INSPECTION REPORT
Sedimentation Structure
J7-I
Black Mesa Mine
Navajo County, Arizona
for
PEABODY COAL COMPANY

Dames & Moore
10139-011-22

EXISTING
MAXIMUM CROSS-SECTION
A-A'
J7-1

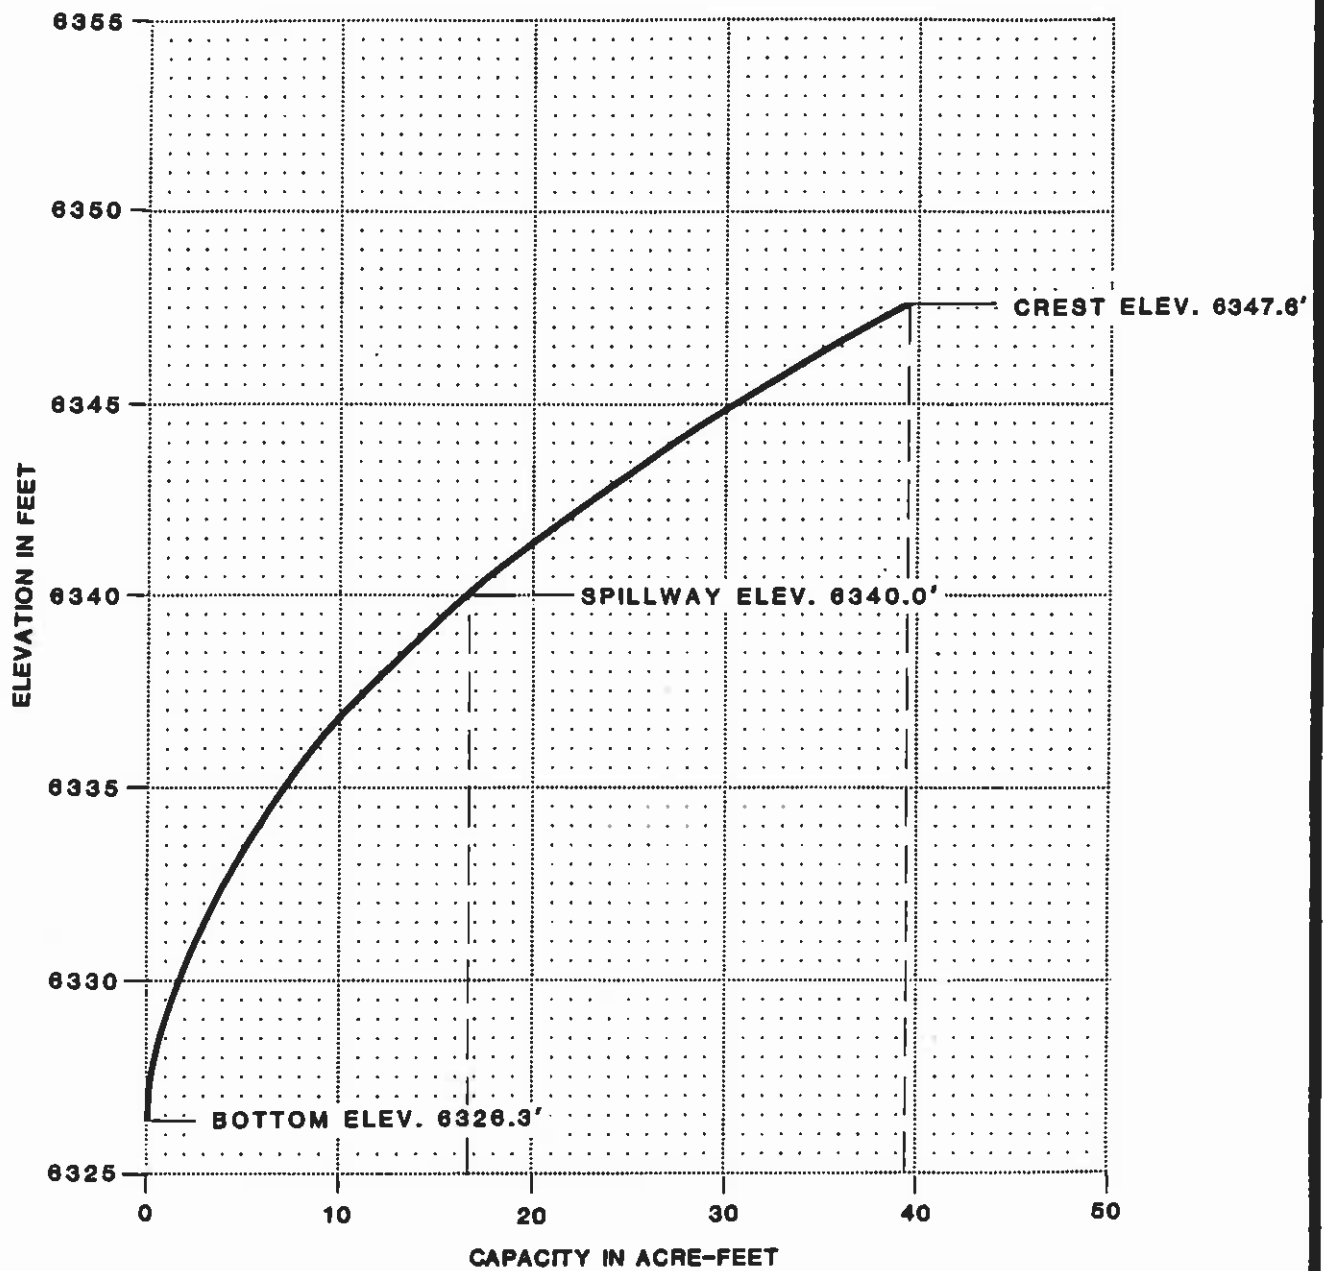
The upstream slope is lower in height and has a flatter slope than the category standard. The downstream slope is steeper than the category standard; therefore, the embankment has factors of safety less than the design minimum.

The inspection of Structure J7-I indicated that the geotechnical problems consist of rill erosion on the upstream slopes; a large gully on downstream slope; heavy erosion at the downstream toe of the embankment and gullies on the right abutment; and a steep downstream slope. Correction of erosion is considered a periodic maintenance task and does not require

remedial action. The downstream slope should be flattened to 4.25 horizontal to 1 vertical to meet stability requirements. Evidence of seepage was noted below the downstream toe of embankment through the sandstone bedrock. Remedial action for this condition is not required at the present time, however, future inspections should check for changes.

CHANNEL PROFILE B-B'
J7-1

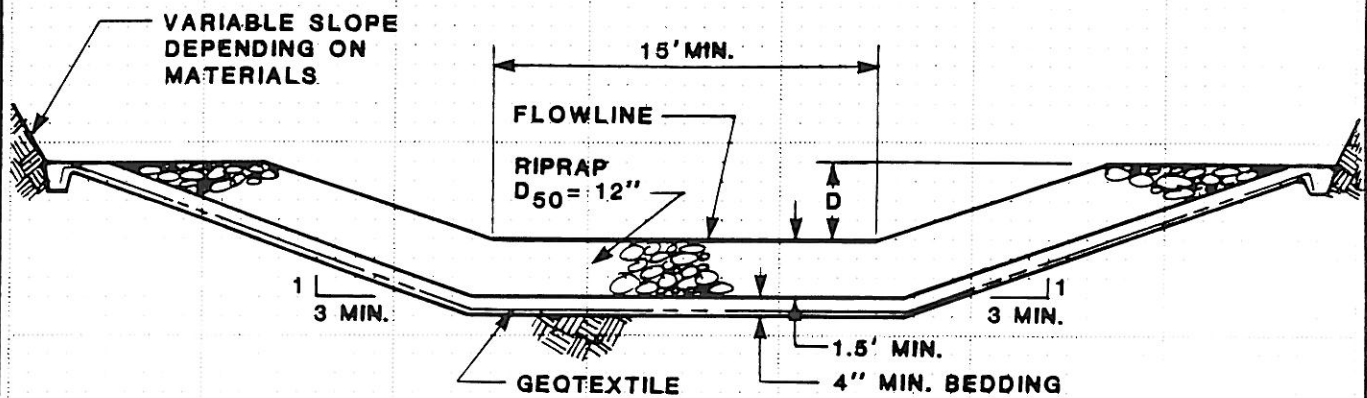
The storage capacity and spillway capacity of Structure J7-I are adequate; however, the spillway does not have an adequate outflow channel or adequate erosion protection. A trapezoidal outflow channel and a stilling basin should be constructed along the alignment B-B' shown in Plate 1. The channel and stilling basin profile is shown in Plate 4 and the required dimensions are shown in Plate 5 and Plate 6. The outflow channel, and stilling basin should be protected against erosion using geotextile and riprap as shown in Plate 5. A trashrack should be installed on the inlet of the CMP to prevent clogging of the spillway.
